**CONTRACT DOCUMENTS & TECHNICAL SPECIFICATIONS & PLANS
ADDENDUM No. 1**

**CAPE HENLOPEN STATE PARK
PARK ROAD - COLLEGE OF EARTH, OCEAN, & ENVIRONMENT
CONTRACT NO. 2013-CH-400
June 14, 2013**

DESIGNED BY:	RKK
DRAWN BY:	RKK
BUILDING NO.:	N/A
DATE:	5/3/13
SCALE:	1" = 30'
SHEET NO.:	C-8
PARKS PROJECT #:	CH-49
CONTRACT #:	2013-CH-400

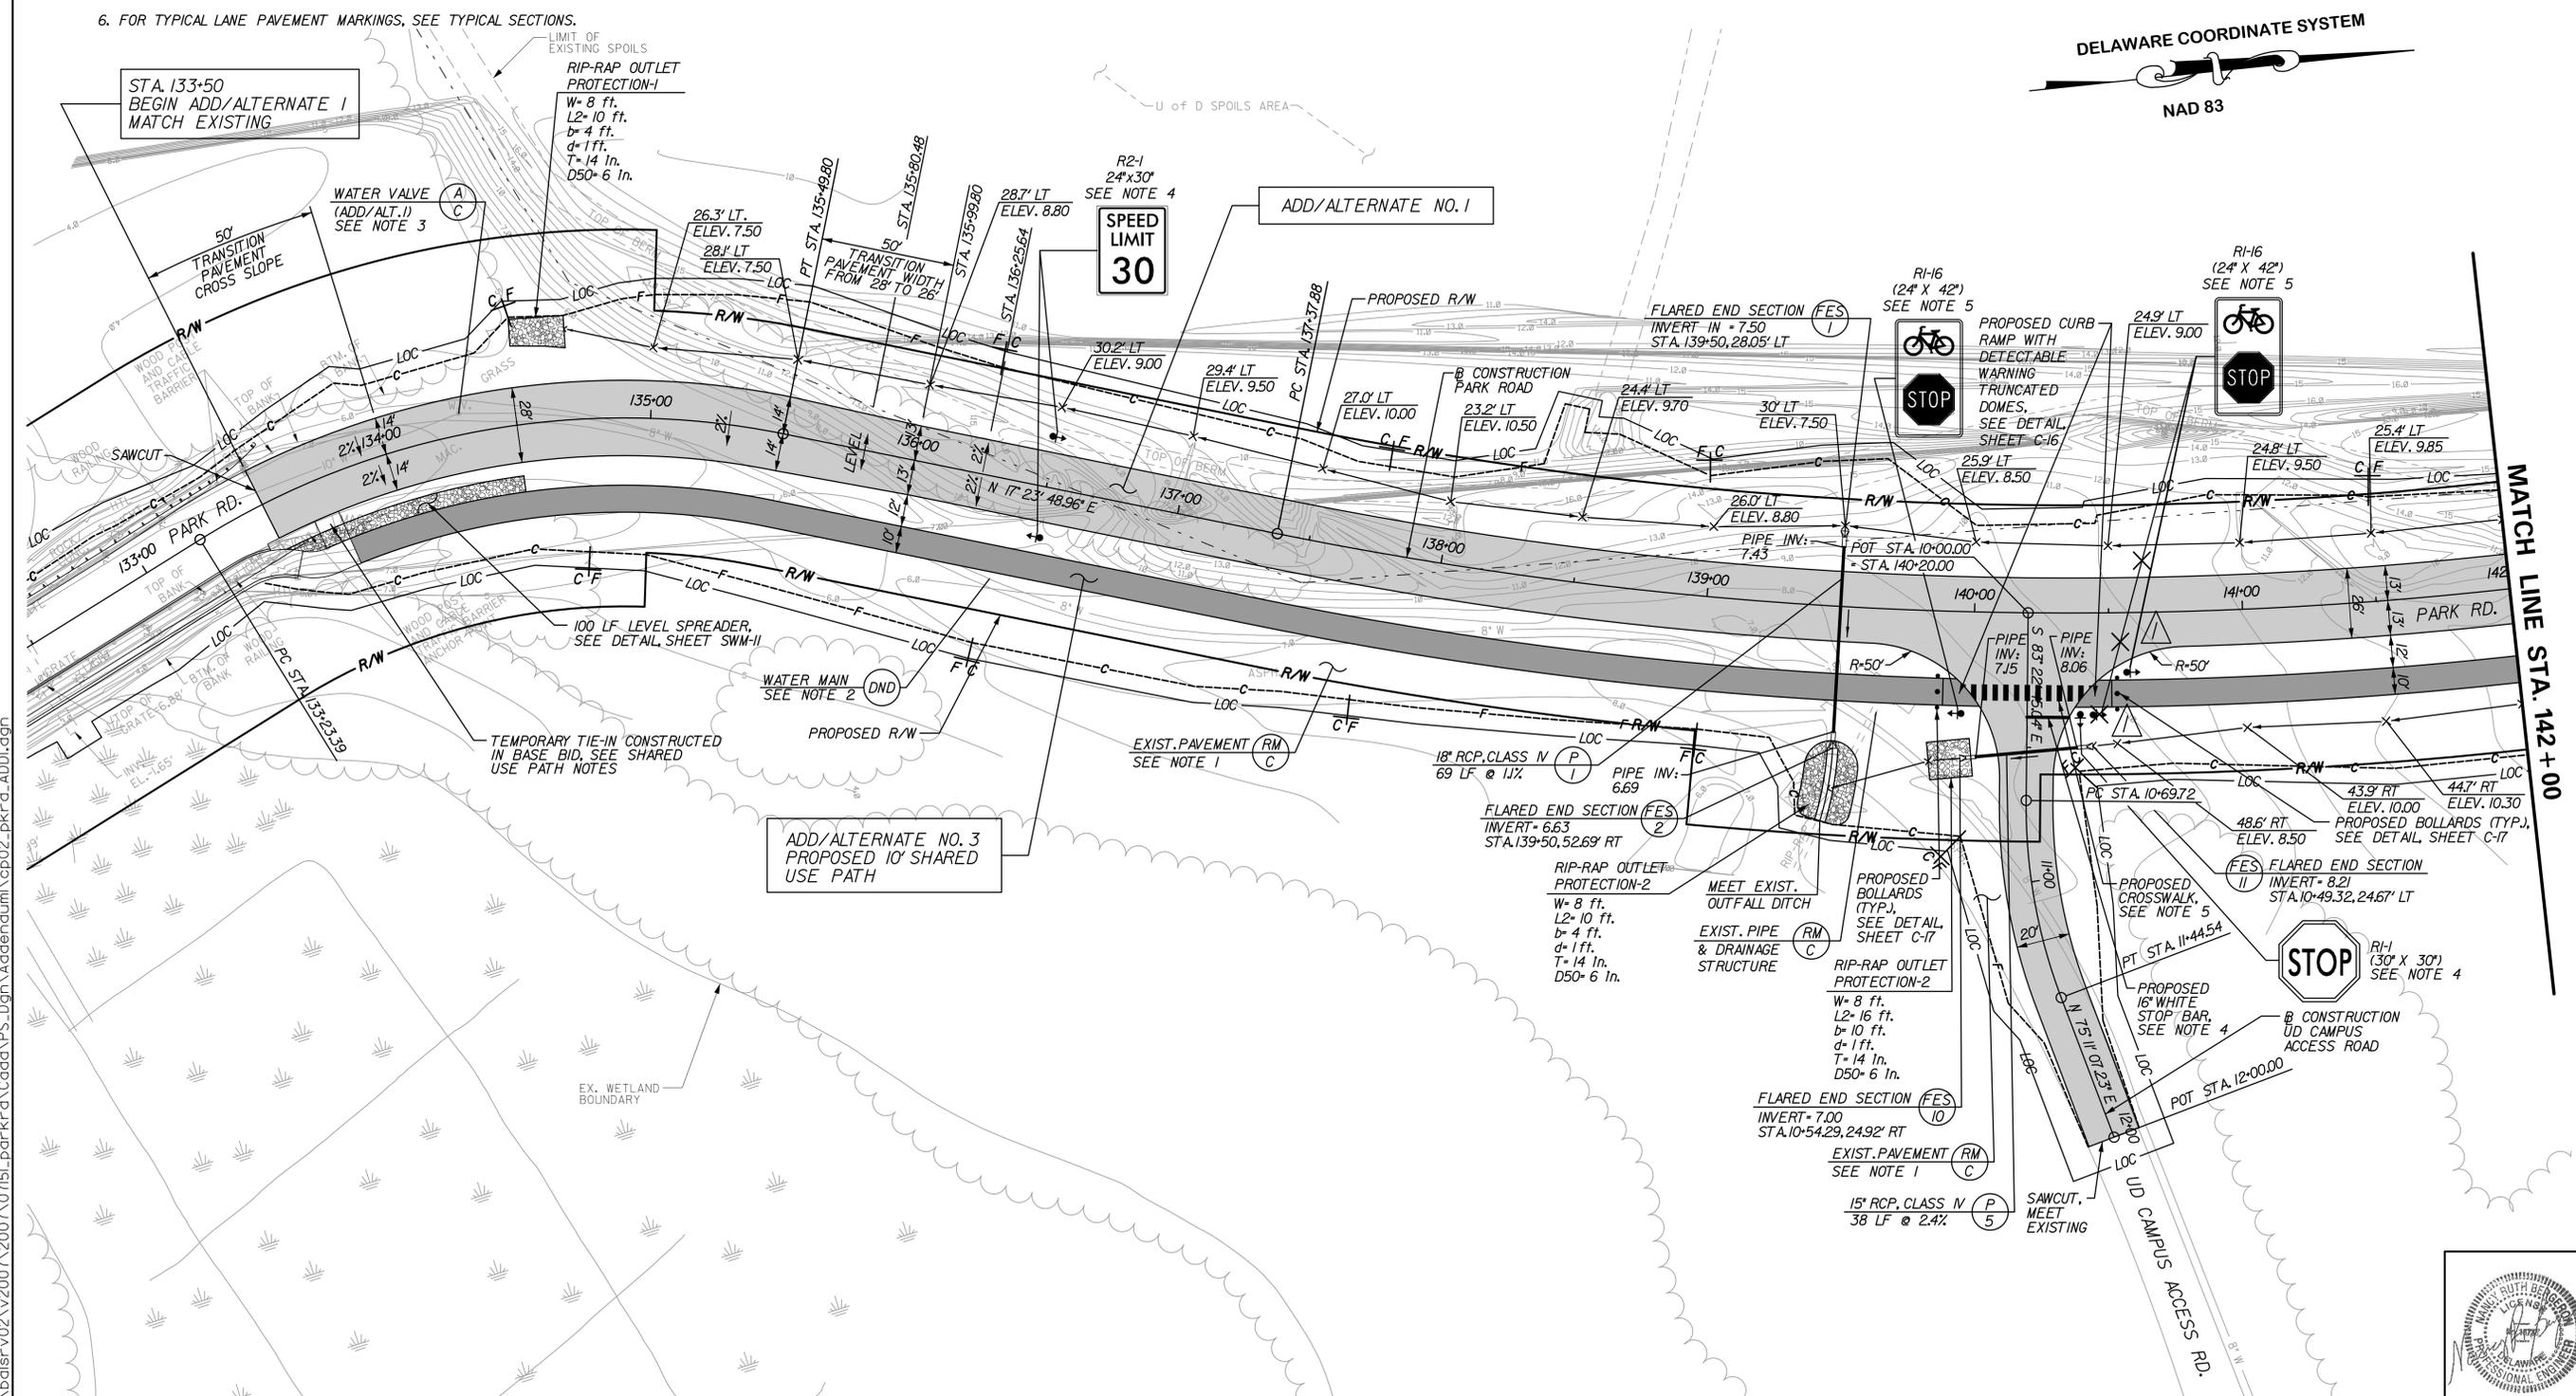
Sheet No. C-8 - Relocation of Sign

DESIGNED BY:	RKK
DRAWN BY:	RKK
BUILDING NO.:	N/A
DATE:	5/3/13
SCALE:	1" = 30'
SHEET NO.:	C-11
PARKS PROJECT #:	CH-49
CONTRACT #:	2013-CH-400

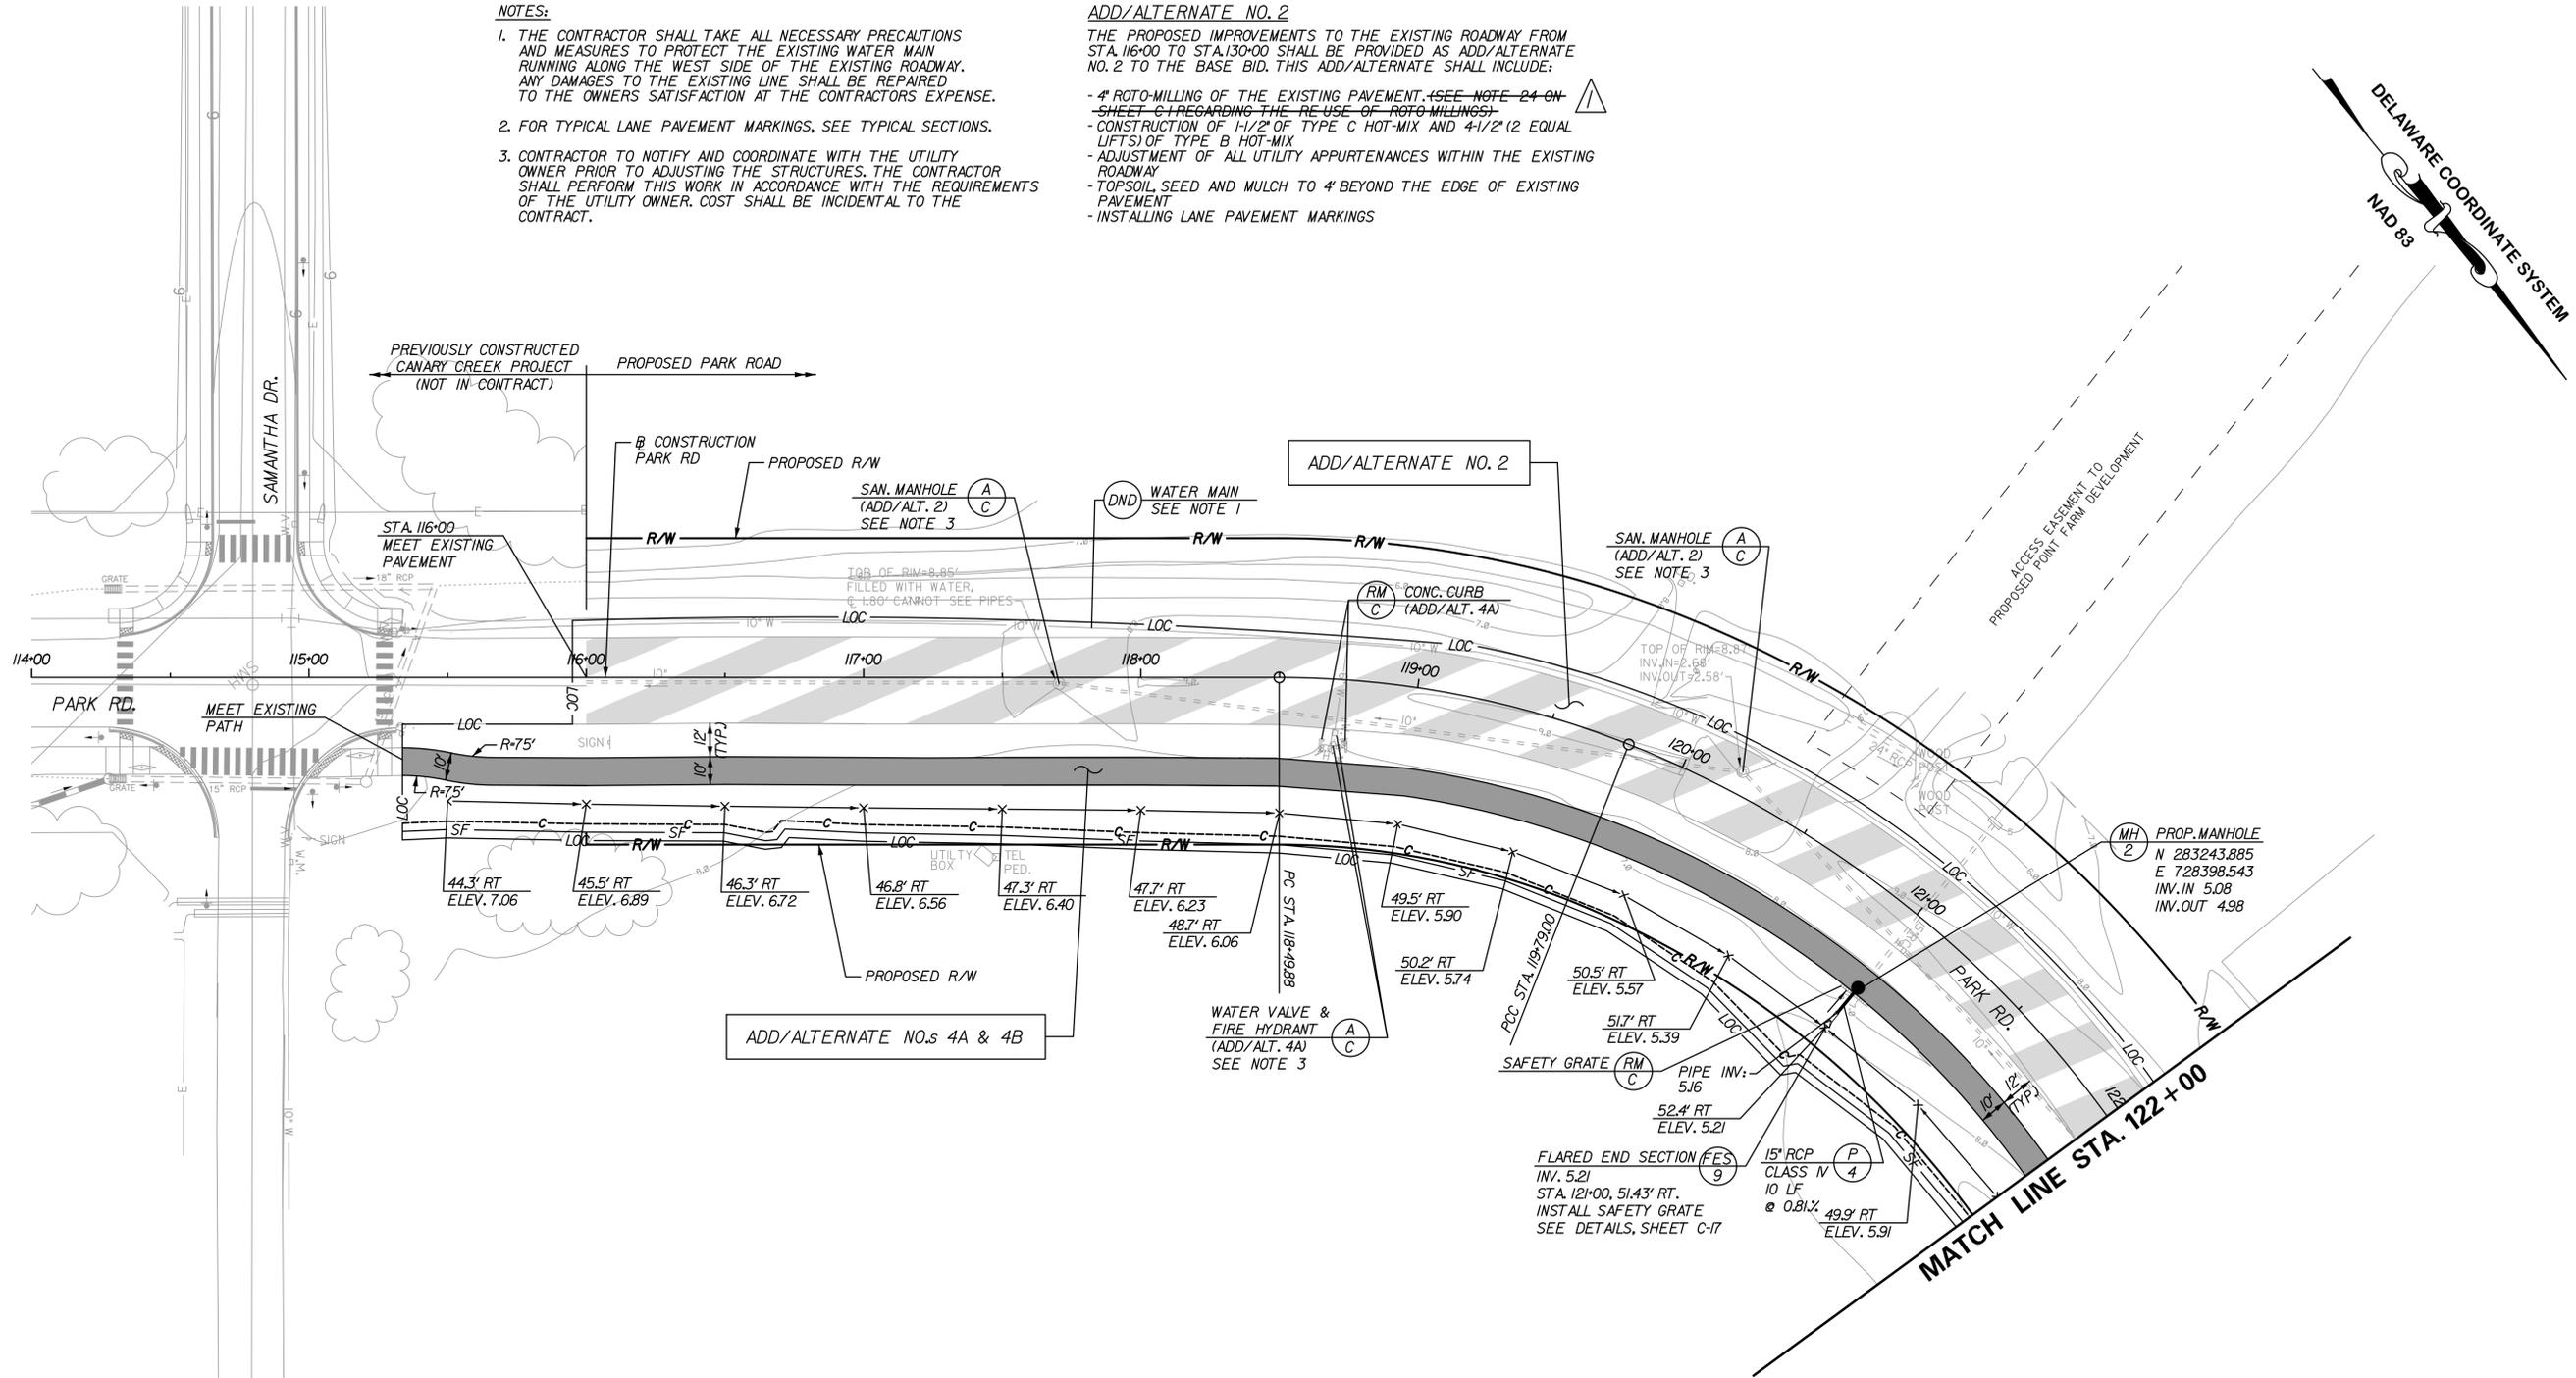
Sheet No. C-11 - Add/Alternates No. 2

DELETE note that references: (See Note 24 on Sheet C1 regarding the use of Roto Millings.)

DESIGNED BY:	RKK
DRAWN BY:	RKK
BUILDING NO.:	N/A
DATE:	5/3/13
SCALE:	1" = 30'
SHEET NO.:	C-12
PARKS PROJECT #:	CH-49
CONTRACT #:	2013-CH-400

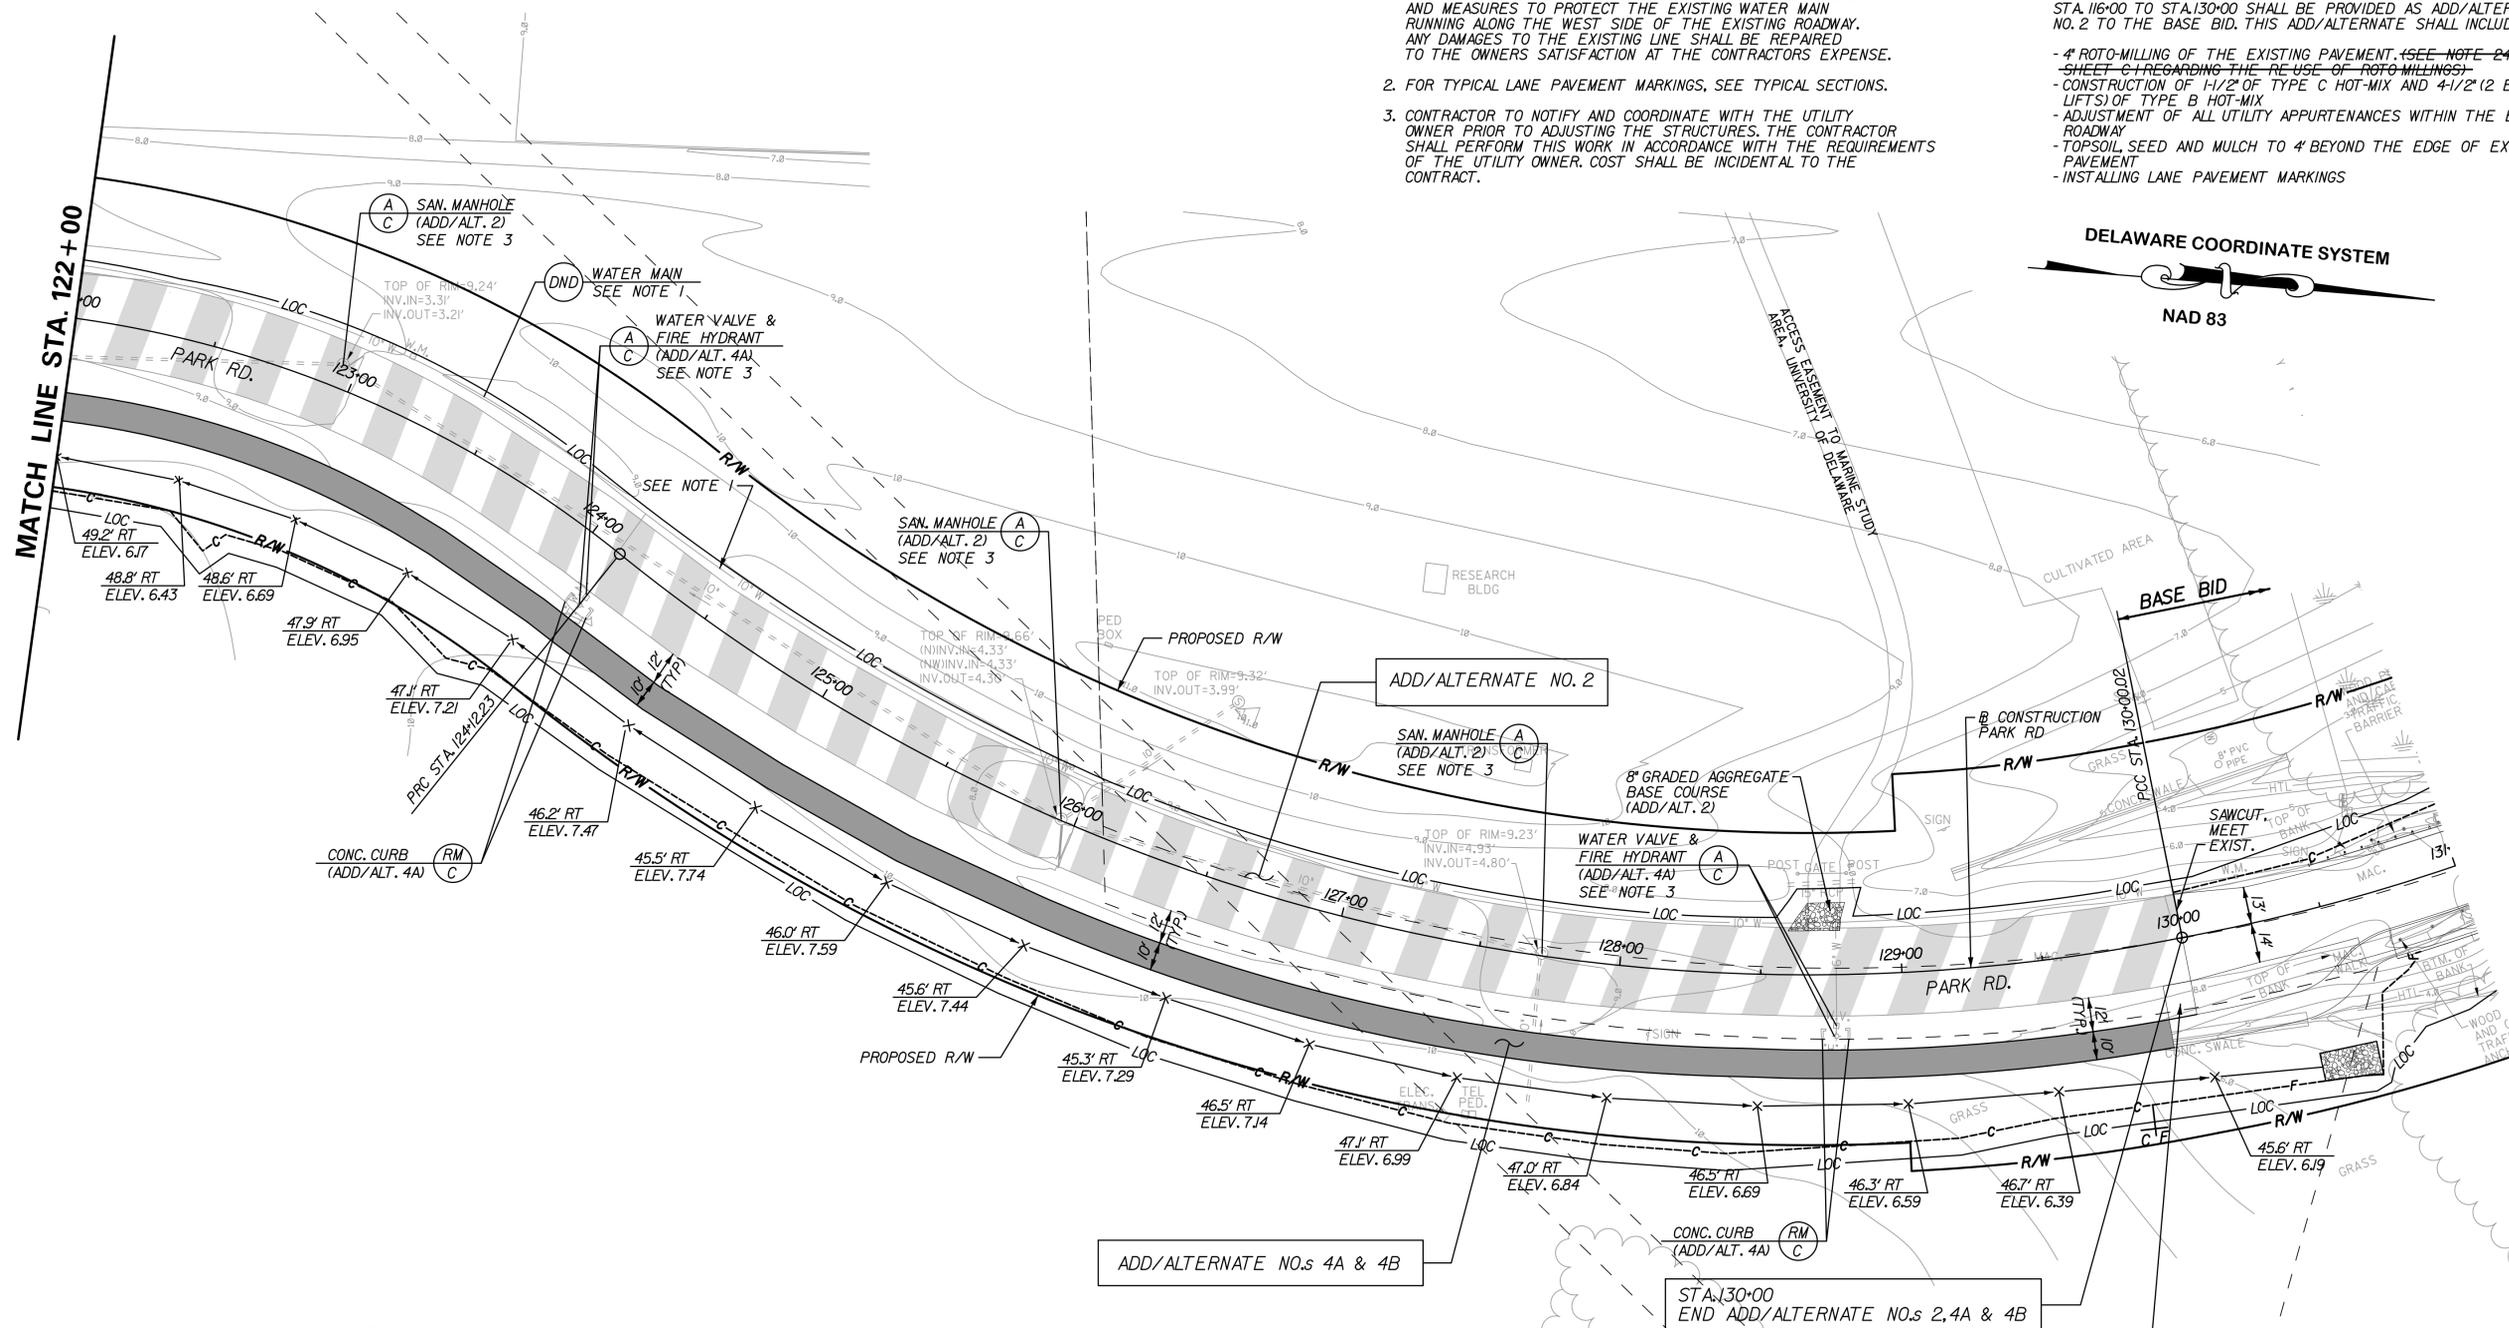
Sheet No C-12 - Add/Alternates No. 2

DELETE note that references: (See Note 24 on sheet C1 regarding the use of Roto Millings).
